Executive Order G-70-23-A

Relating to the Modification of the Certification of
Exxon Balance
Phase II Vapor Recovery System

Executive Order G-70-23-A
Exxon Balance Phase II
Vapor Recovery System

Exhibit 1

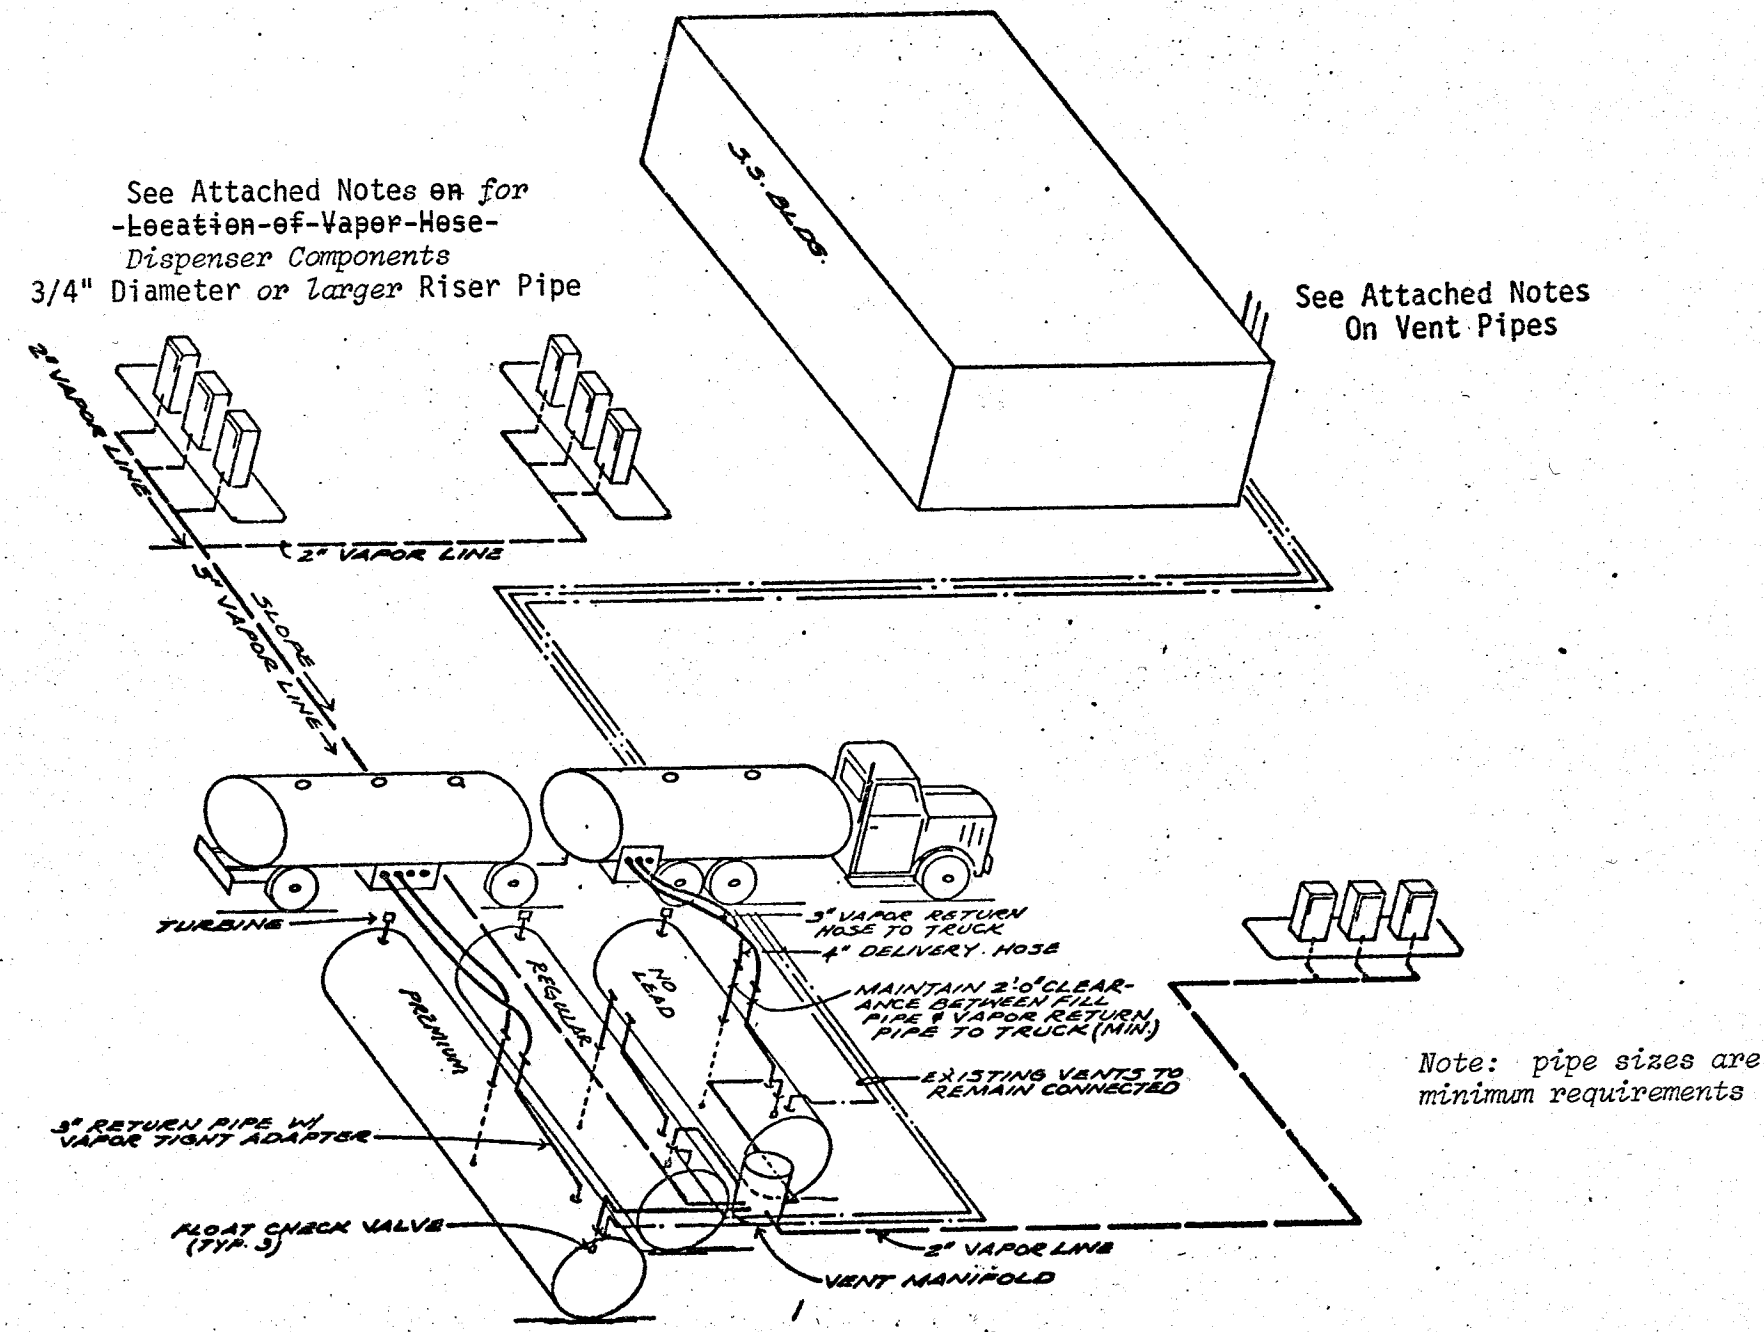
IT IS ORDERED AND RESOLVED: That the certification issued on August 4, 1978, for the Exxon Balance Phase II vapor collection and disposal system is hereby modified to eliminate previously listed restrictions on vapor hose swivels and to allow installation of any swivels that have State Fire Marshal approval and have a minimum inside diameter of 0.495 inches, provided that the swivel arrangement chosen prevents kinking of the vapor hose. The certification is further modified to change the nozzle to a modified one incorporating a larger diaphram, to allow adjusting the length of each vapor return hose according to dispenser island width, to require selection of product hose length to provide for full extension of the vapor return hose, to allow use of alternate recirculation traps and associated plumbing configurations, to allow the use of larger diameter underground piping, and to eliminate the restriction on product hose diameter since product flow is limited by the flow limiter. The system hereby modified is certified to be at least 90% effective in self-serve use and at least 95% effective in attendant use at gasoline service stations in conjunction with Phase I vapor recovery systems which have been certified by the Air Resources Board. The system is described in Exhibits 1 and 2, attached hereto.

1. Nozzle	Emco Wheaton A3003 (Extended Spout, *Large Diaphram*) Vapor Recovery Nozzle *(unleaded)* *Emco Wheaton A3003 (Short Spout, Large Diaphram) Vapor Recovery Nozzle (leaded)*	GVRC 001:007:25		
~~2. Liquid Hose~~	~~5/8 in. ID by 9 feet~~		~~3/4 in. by 9 ft.~~

2. Vapor Hose	5/8 in. ID by 8 feet		3/4 in. ID by 8 ft.	
3. Riser	3/4 in. *or larger* diameter Galvanized Pipe			
4. Swivels				
a. Nozzle	~~Single Plane OPW-43~~ *State Fire Marshal Approved. 0.495 in. ID minimum*	~~GVRG-005:008:6~~

b. Island	~~Double Plane 90 OPW-36-E~~ *State Fire Marshal Approved. 0.495 in. ID minimum*	~~GVRG-005:008:8~~		
5. Flow Limiter	Emco Wheaton A-10	GVRC 001:007:1

6. Recirculation Trap	Emco Wheaton A008-001	GVRC 001:007:4	*OPW 78, 78-S, 78-E, or 78-ES*	*GVRC 001:008:13*

5. Each vapor hose shall be located such that the center line of the hose fitting, at the recirculation trap *(if externally mounted) or at the dispenser cabinet swivel mounting (if trap is internally mounted),* is not more than 3-1/2 inches above the top surface of the island and is as close as possible to the top surface of the island.

6. *For dispenser islands greater than 5 feet in width, each vapor hose length shall not be longer than the sum of one-half the dispenser island width, in feet, plus 6 feet.*

7. *State Fire Marshal approved swivels (and offsets if necessary) for this system shall be selected and installed on hoses to prevent hose kinking.*

8. *Product hoses one foot or more longer than the vapor hose shall be installed at each dispenser to provide for full extension of the vapor return hose.*

9. *If any OPW 78 series recirculation trap is internally mounted in any dispenser, the top of the recirculation trap shall not be higher than the top surface of the dispenser island and a vapor recovery piping shear section which meets State Fire Marshal requirements shall be installed.*

10. *On dual dispensers dispensing the same product from both sides, the vapor return lines may be connected to a single OPW 78 series recirculation trap mounted internally in the dispenser.*
